FLIGHT READINESS STATEMENT
STS-88/ET-97
EXTERNAL TANK PROJECT
PRE-FLIGHT REVIEW

October 22, 1998

STS-88/ET-97
Pre-Flight Review

Implementation of Dual Cover Pass

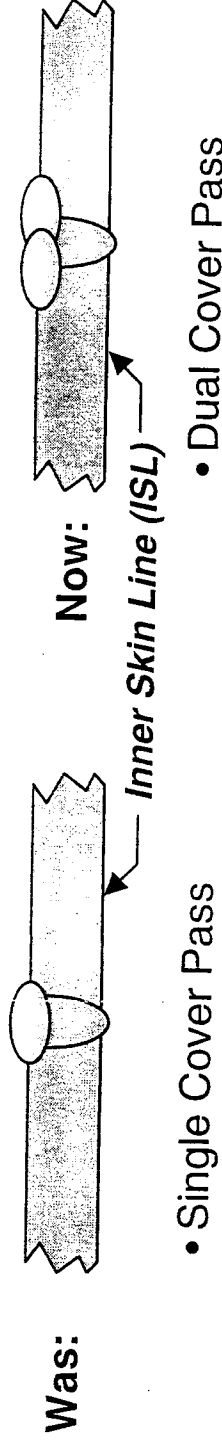
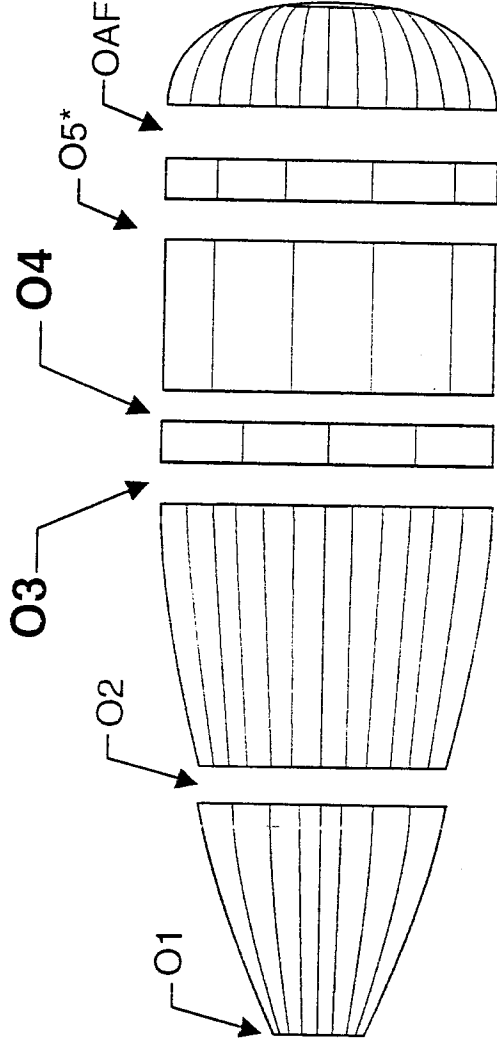
- Implemented dual cover pass weld process on the LO2 tank O3 and O4 welds

- High incidence of pre- and post-proof cracks on circumferential welds at longitudinal weld intersections
- Dual cover pass reduces sensitivity to intersection cracking and subsequent repairs
 - Eliminates the residual stress element associated with cross-over cover passes
- Implemented on STS-95/ET-98 at several locations
 - LO2 tank: O5 weld
 - LH2 tank: H1 thru H8 welds

LH2 Tank Post Proof X-Ray Indications

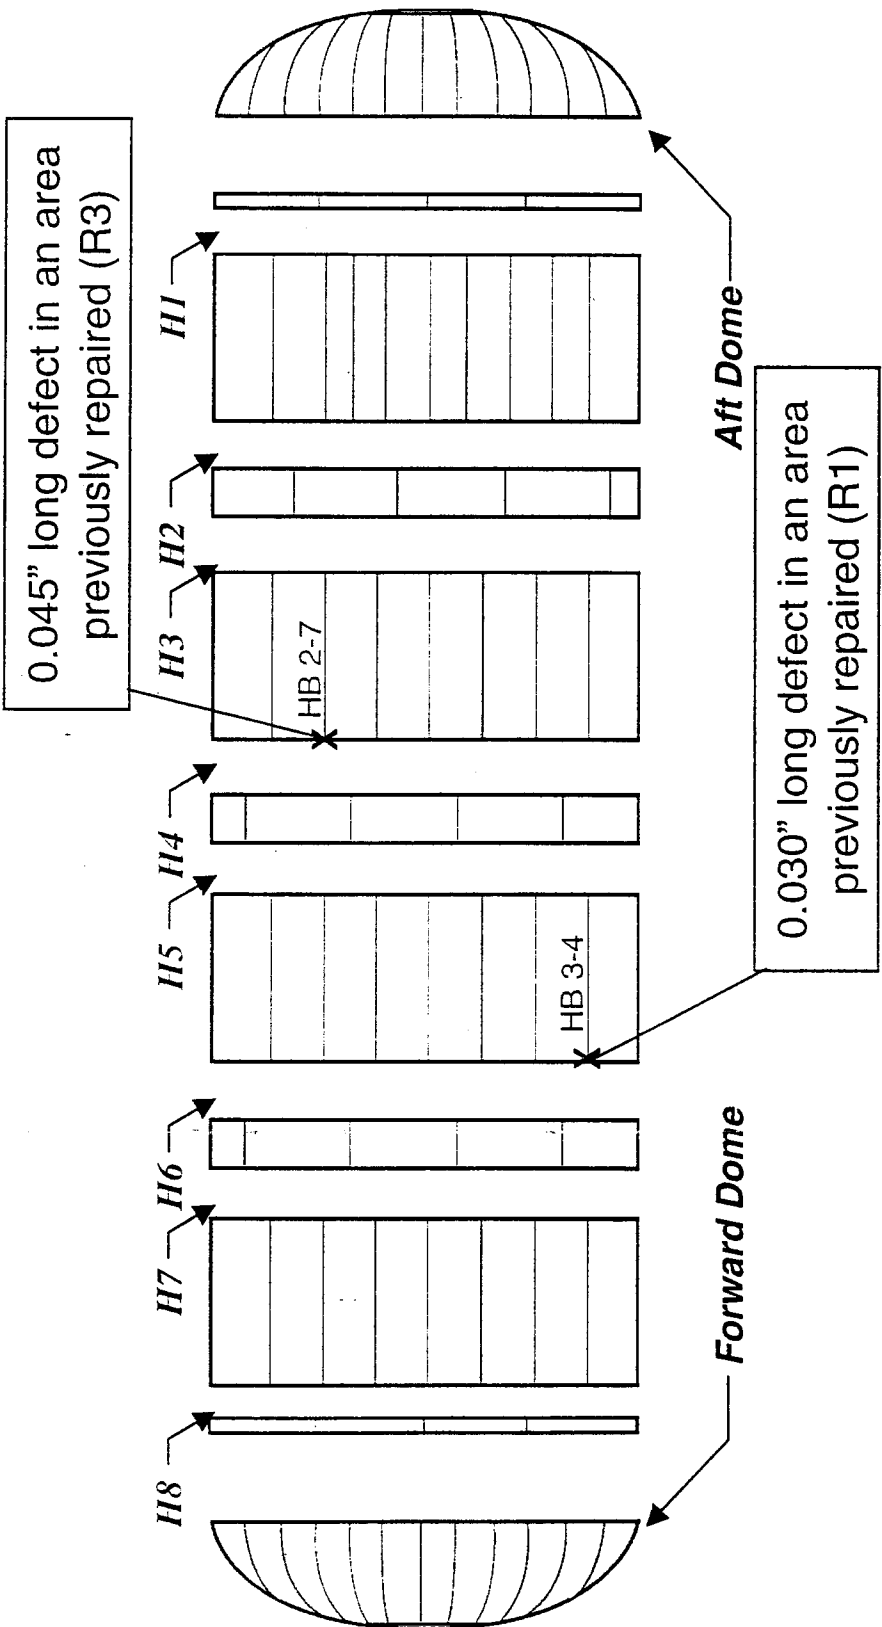
- Acceptance of small x-ray indications on LH2 tank H4 and H6 welds

- Two linear indications detected by x-ray after ET-97 LH2 tank proof test
 - H4 weld @ 779" 0.045" indication
 - H6 weld @ 390" 0.030" indication
- Because of the small size of the indications, an analysis performed to determine suitability of use as is disposition
- ✓ • MAF and MSFC Fracture Control Boards approved indications "use-as-is"
